Mount Piper to Wallerawang Transmission Line Upgrade Project

Submissions Report

December 2025

Figure 3.1. Access tracks that have been re-categorised – Map 1

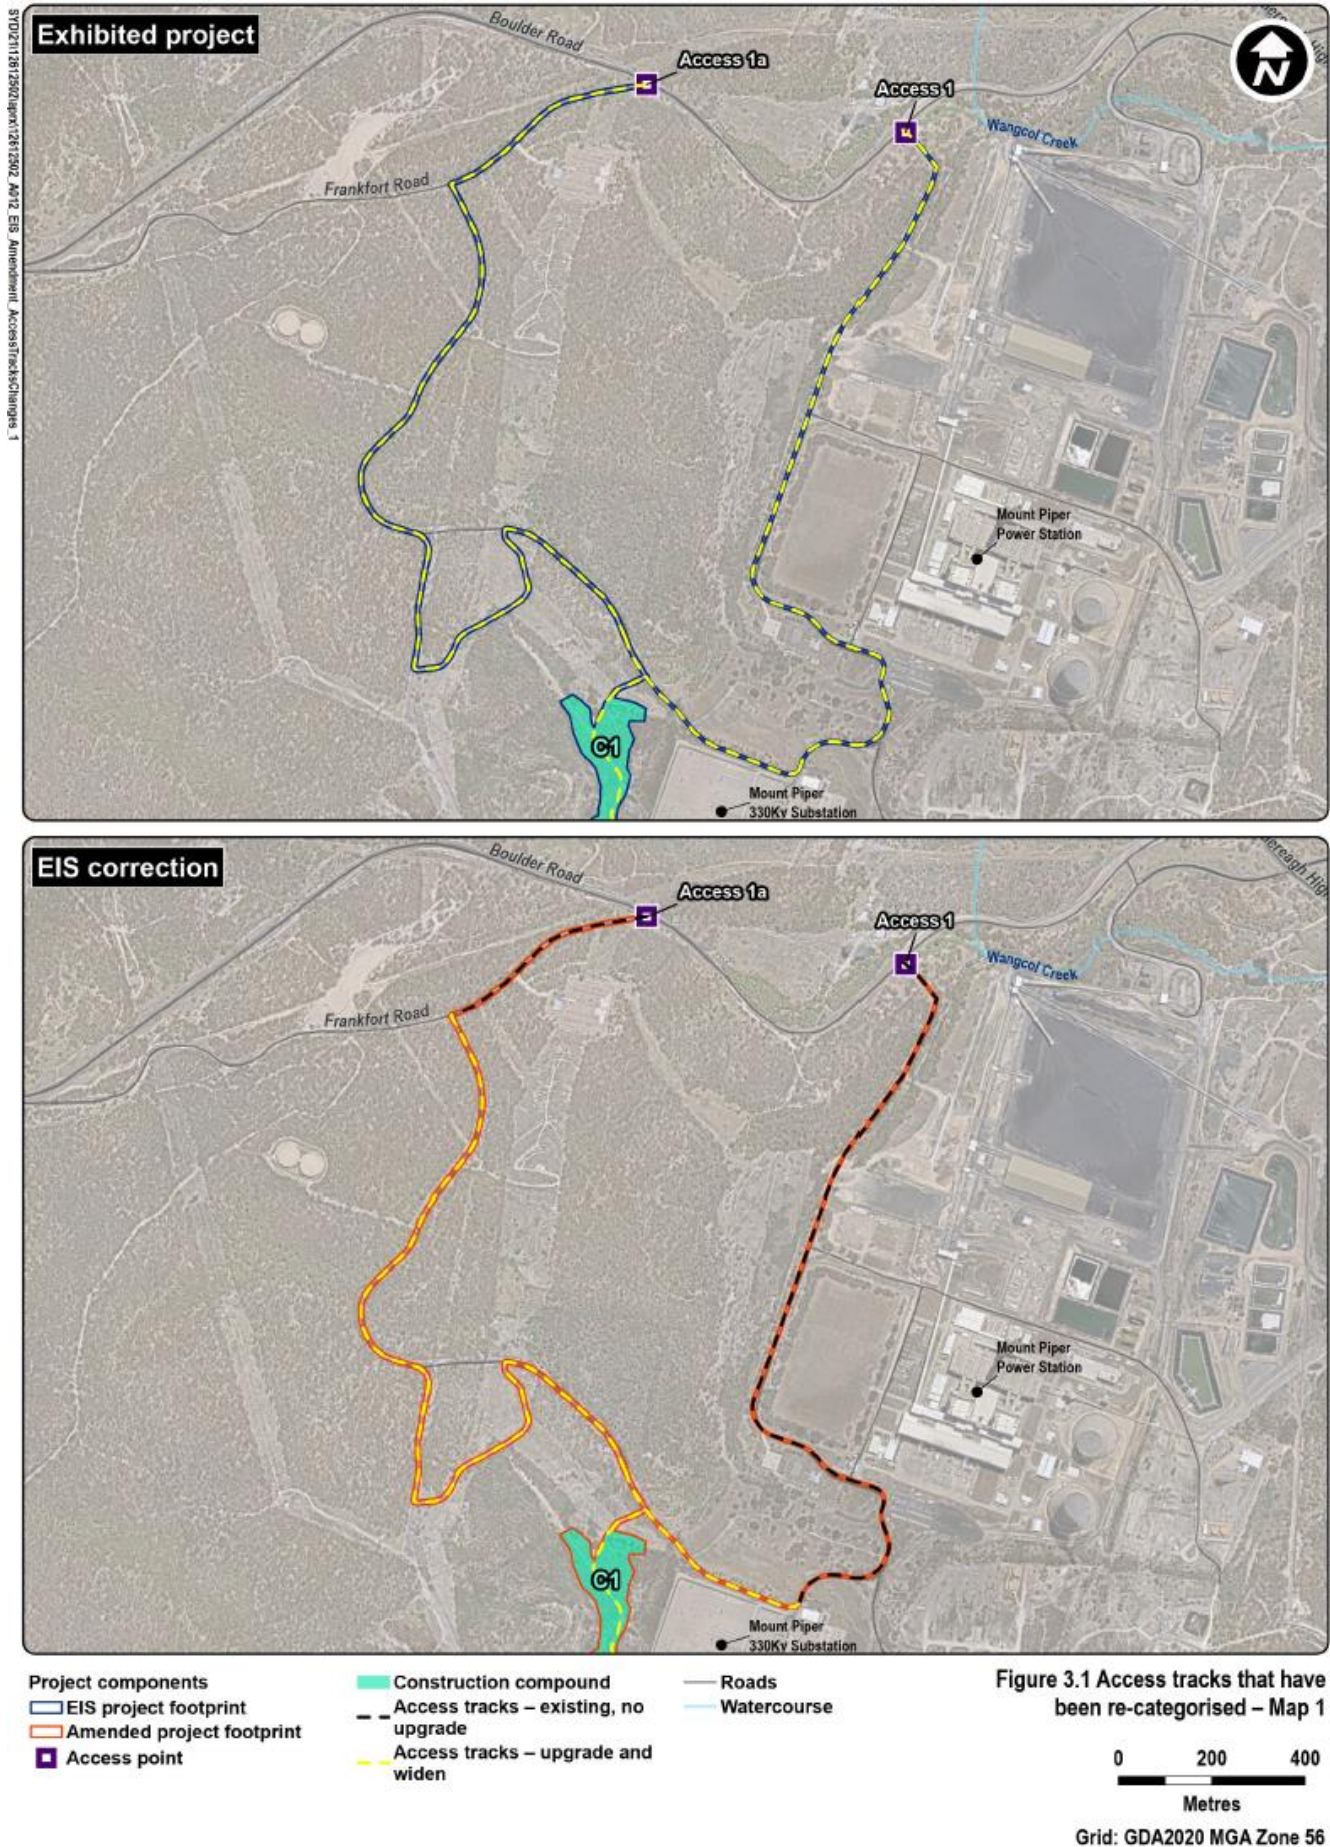
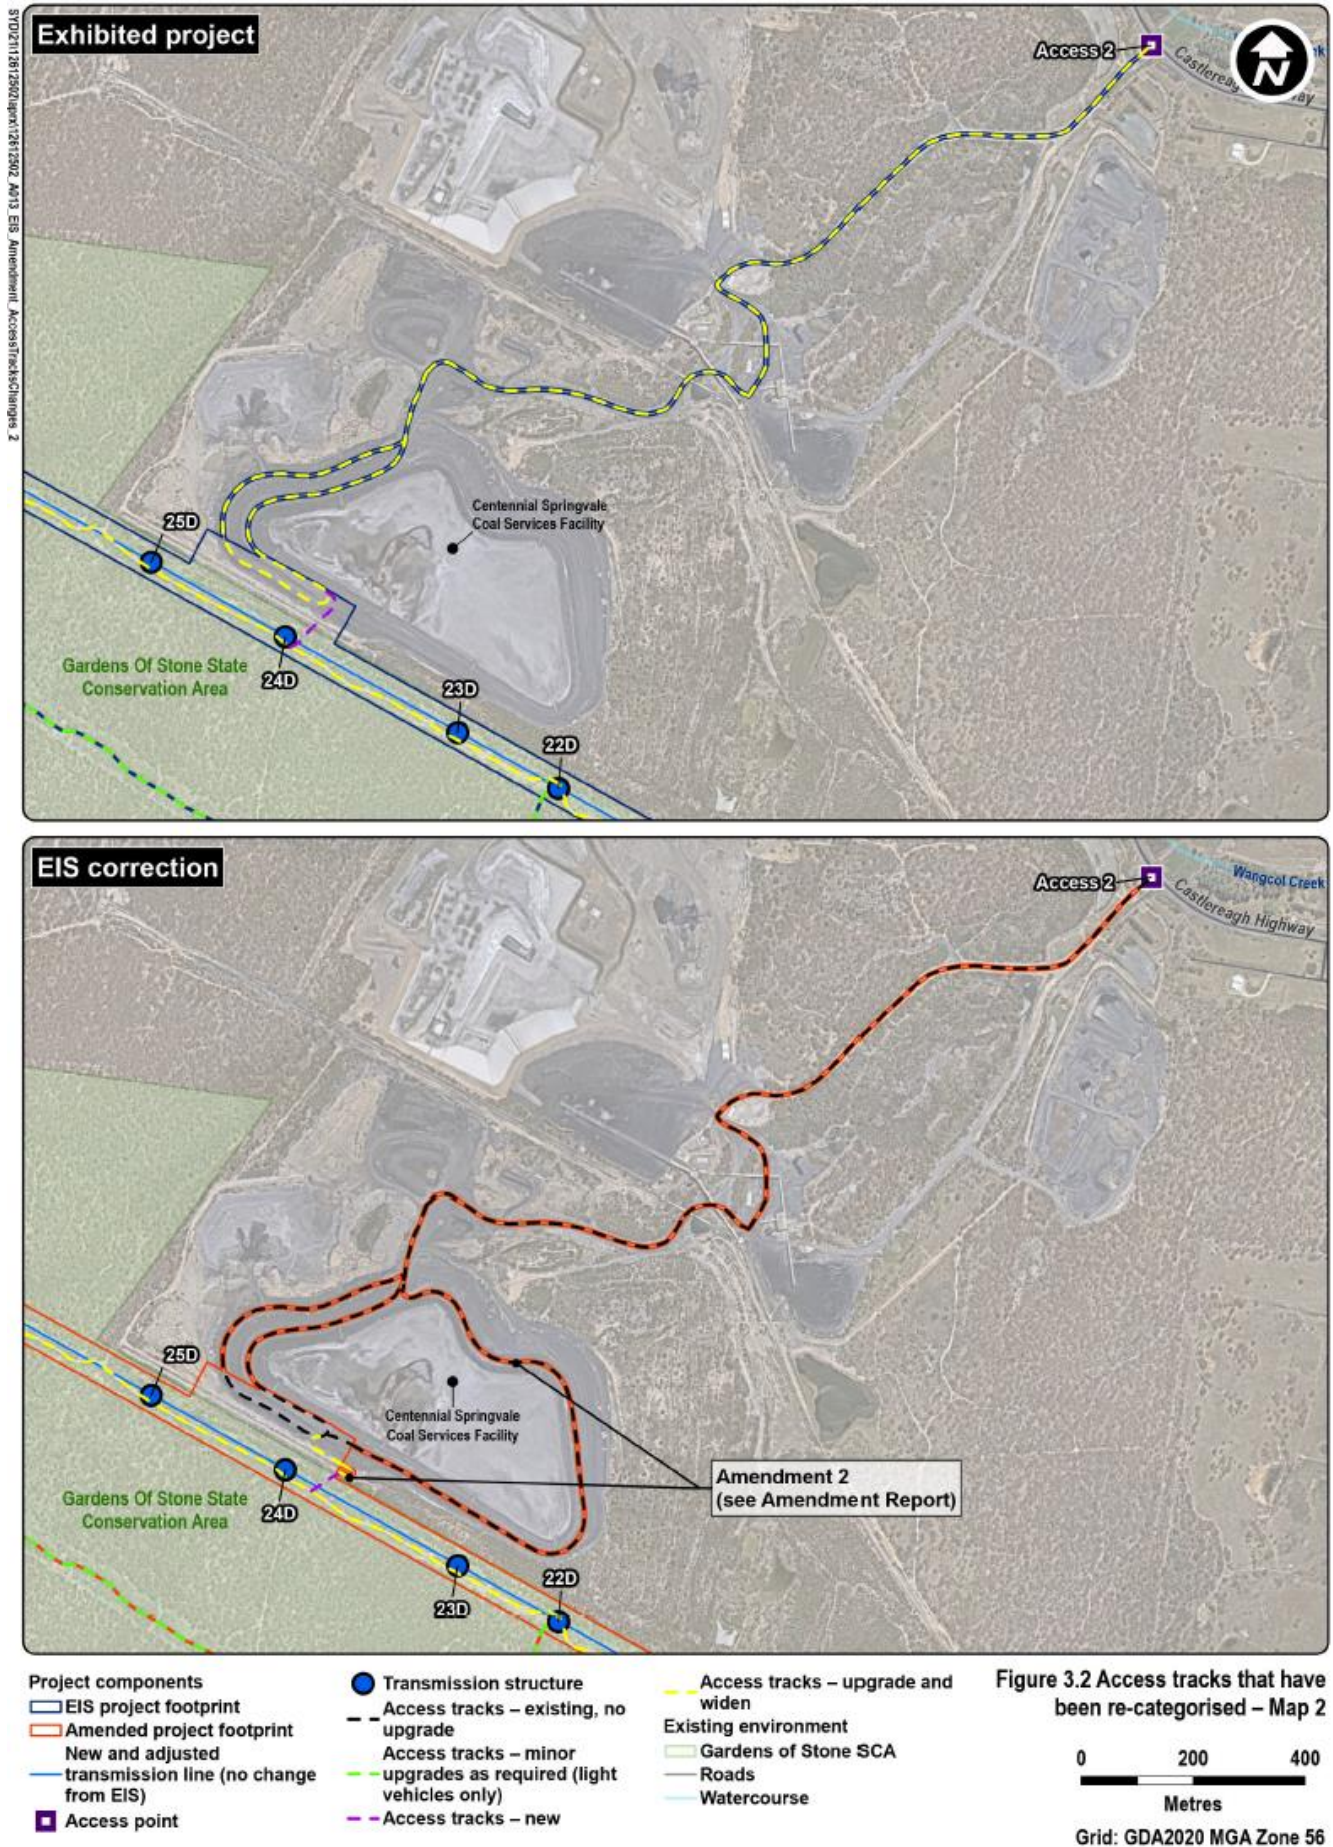
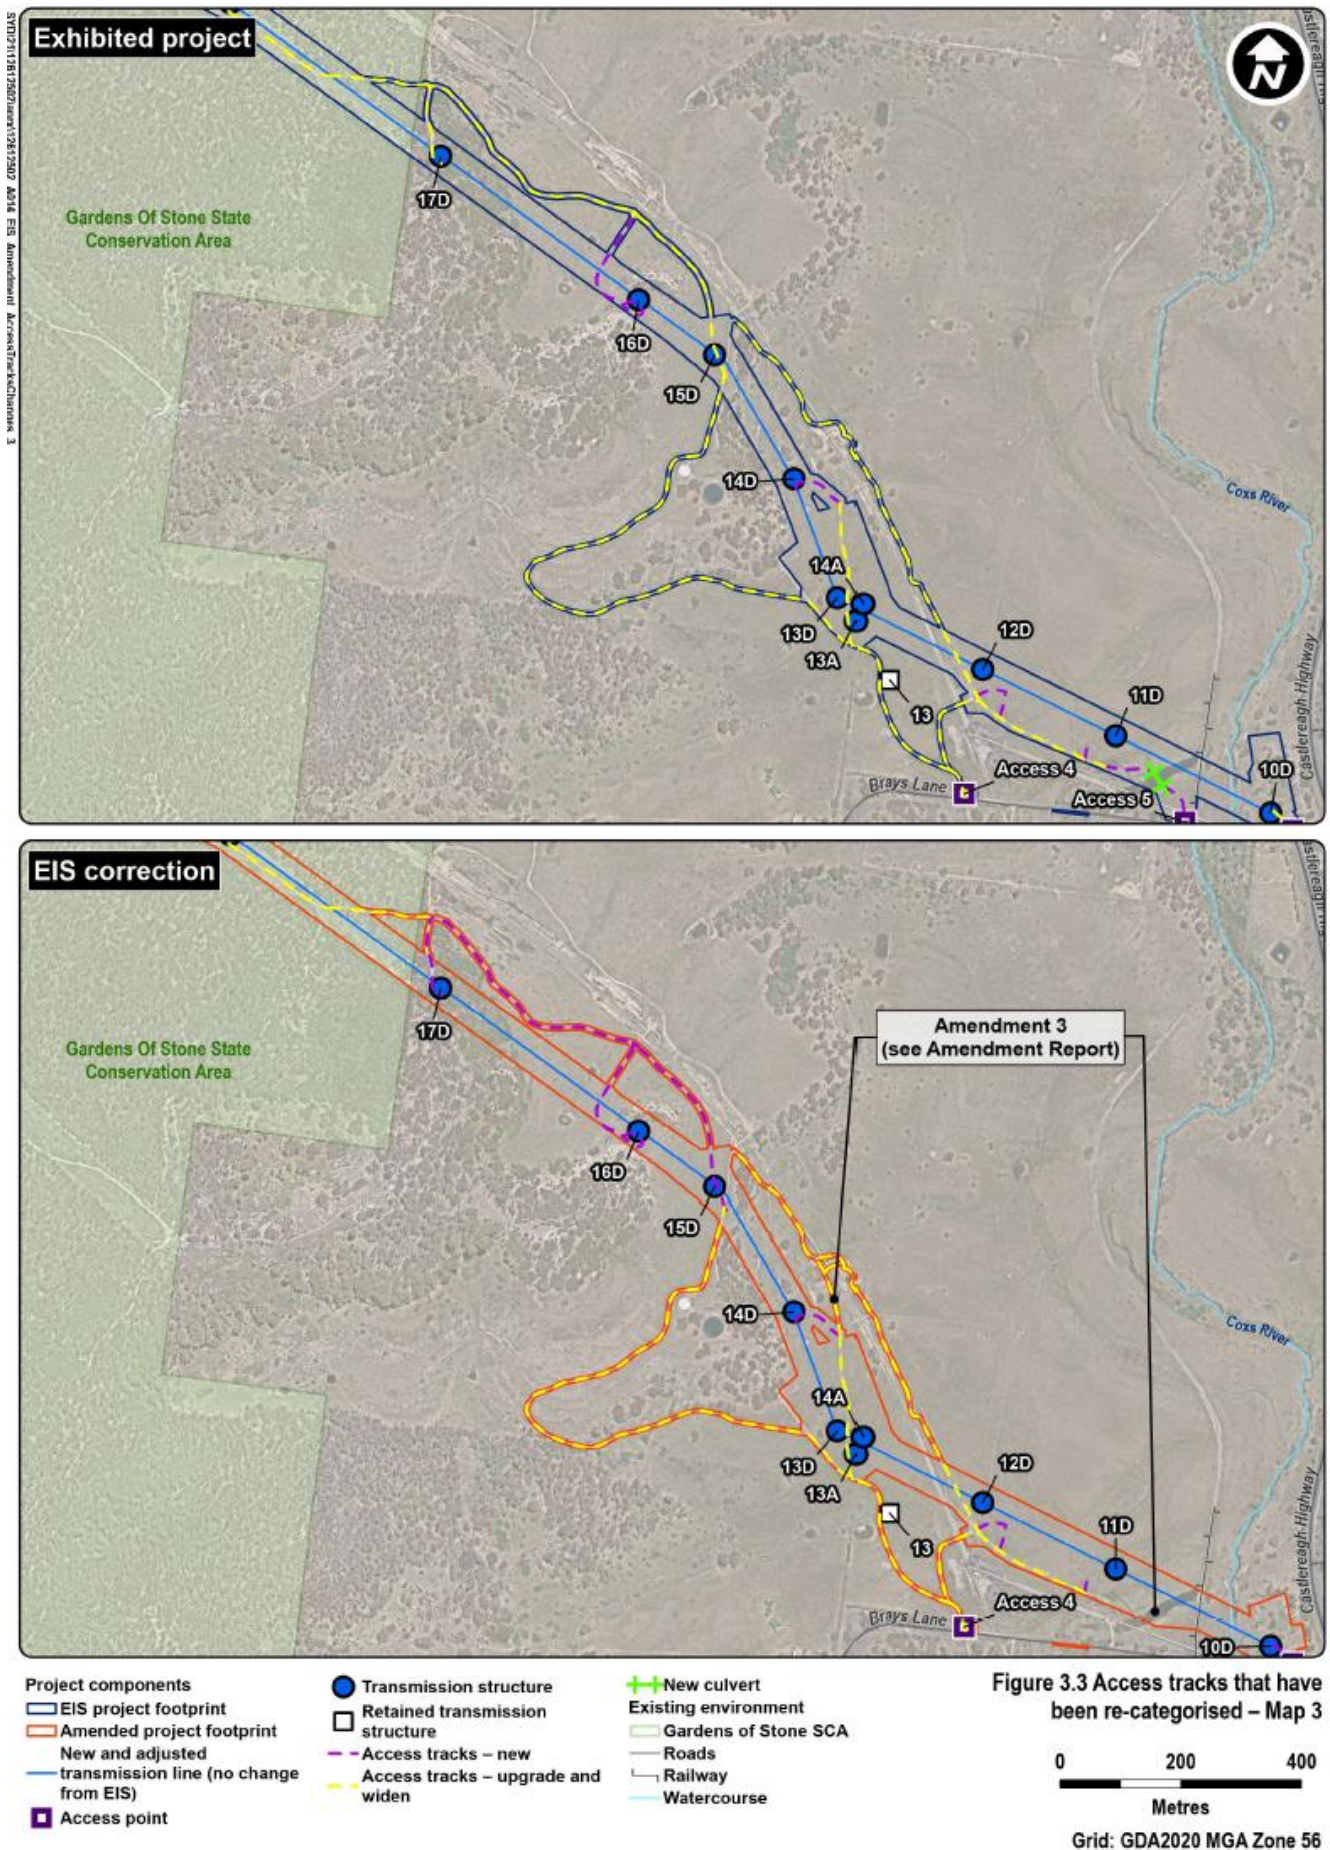
Since exhibition of the EIS, it was identified that some existing tracks were incorrectly identified as requiring upgrade and widening. This was mostly related to tracks located on properties owned by EnergyAustralia, Centennial Coal and on the former Wallerawang Power Station site. These tracks have been re-categorised and are shown in Figure 3.1 to Figure 3.4. The re-categorised tracks are also outlined in the Amendment Report (Transgrid, 2025a) and the revised project description (Appendix A of the Amendment Report).
